PCN #: 2400

PCN Title: Additional Qualified (AT) Assembly Test Site

PRODUCT CHANGE NOTICE**PCN-2400 REV 1**

QFN1515-9 PAM8013AKR & PAM8015AKR Marking Change

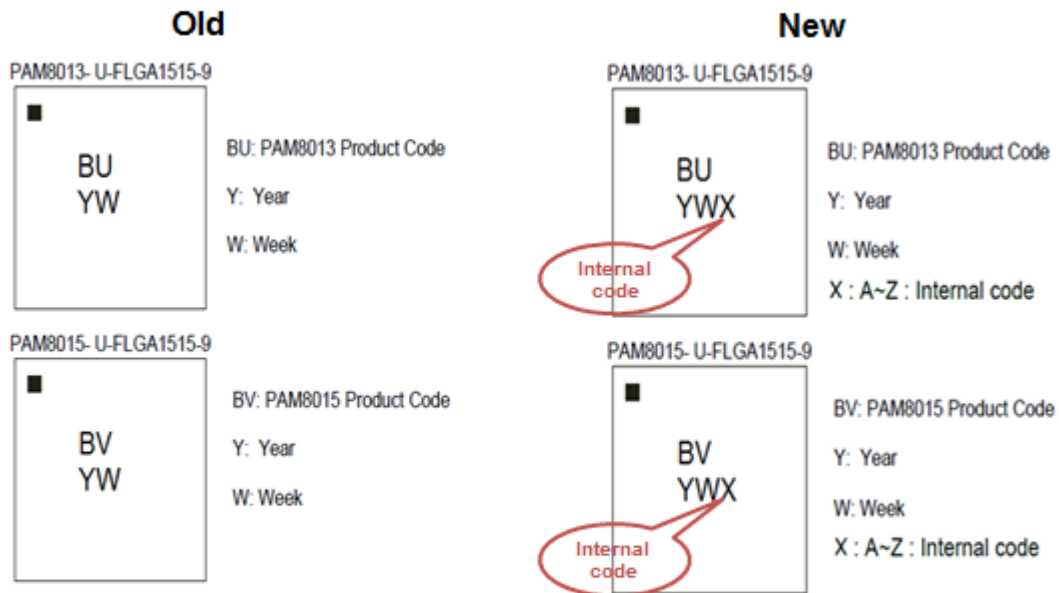
Use internal code to distinguish SAT or CAT.

Note: internal code means day of week.

Sun	Mon	Tue	Wed	Thu	Fri	Sat
CAT	Green	T	U	V	W	X	Y	Z
SAT	Green	A	B	C	D	E	F	G
